**CITY & BOROUGH OF WRANGELL, ALASKA
WRANGELL HARBOR ANODES**

ADDENDUM TO THE CONTRACT

Addendum No:	1	Current Bid Opening Date: October 2, 2023 at 2:00 P.M.
Pages This Addendum:	6	
Previous Addenda:	NONE	Previous Bid Opening Date: October 2, 2023 at 2:00 P.M.

SHEET TITLE:
ADDITIVE ALT. A
PILE SCHEDULE AND DETAILS

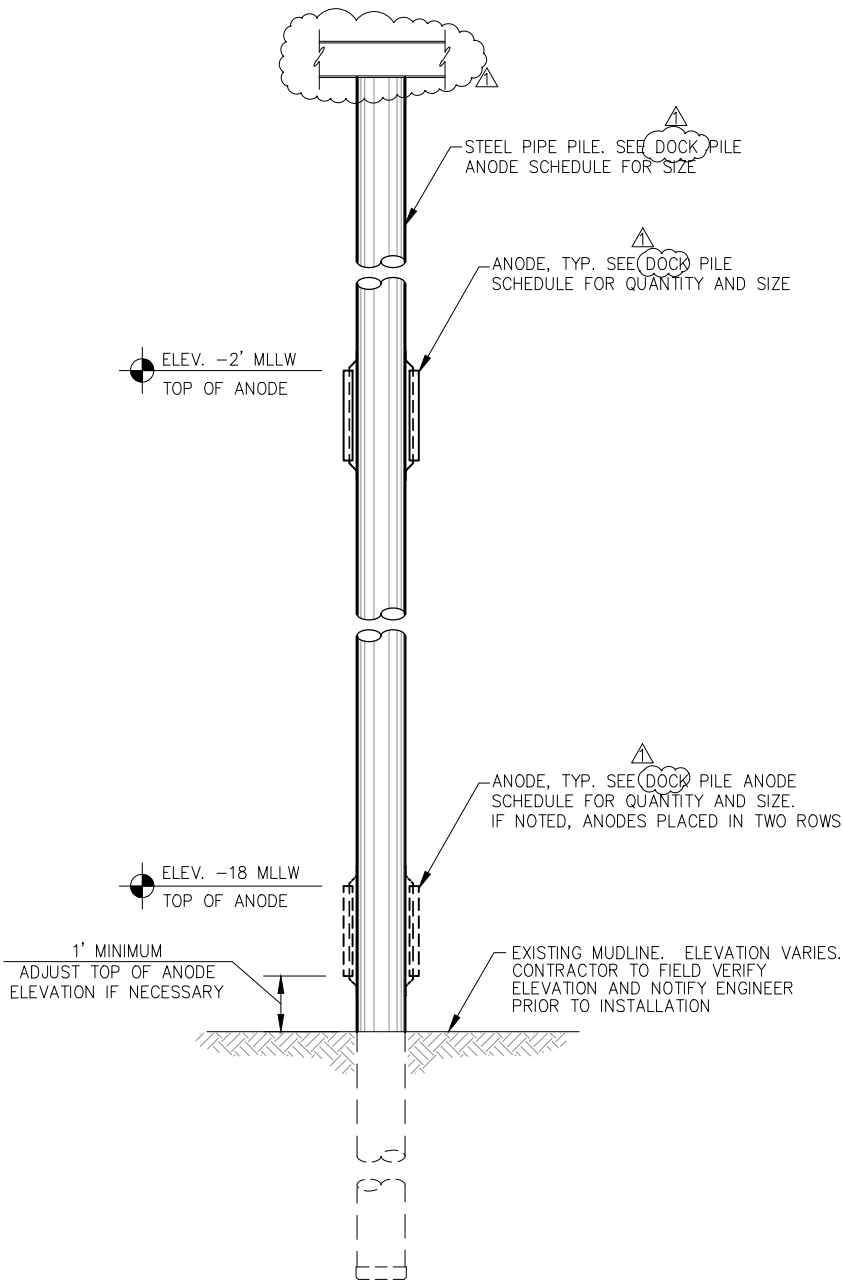
2. Drawing Sheet 3.02, Additive Alt. A Pile Schedule and Details, ***Replace*** the drawing sheet in its entirety with the attached sheet 3.02.
3. Drawings Sheet 4.03 ADDITIVE ALTERNATE B, DOCK SECTION, ***Add*** the following note to fender pile anodes “Align anodes with dock face so that they do not protrude beyond the dock face”

ANODE SCHEDULE			
TYPE	DIMENSION	NOMINAL WT	QUANTITY
1	4x4x72	115 LBS	—
2	6x6x60	210 LBS	110
3	6x6x72	260 LBS	18
4	6x6x24	86 LBS	8
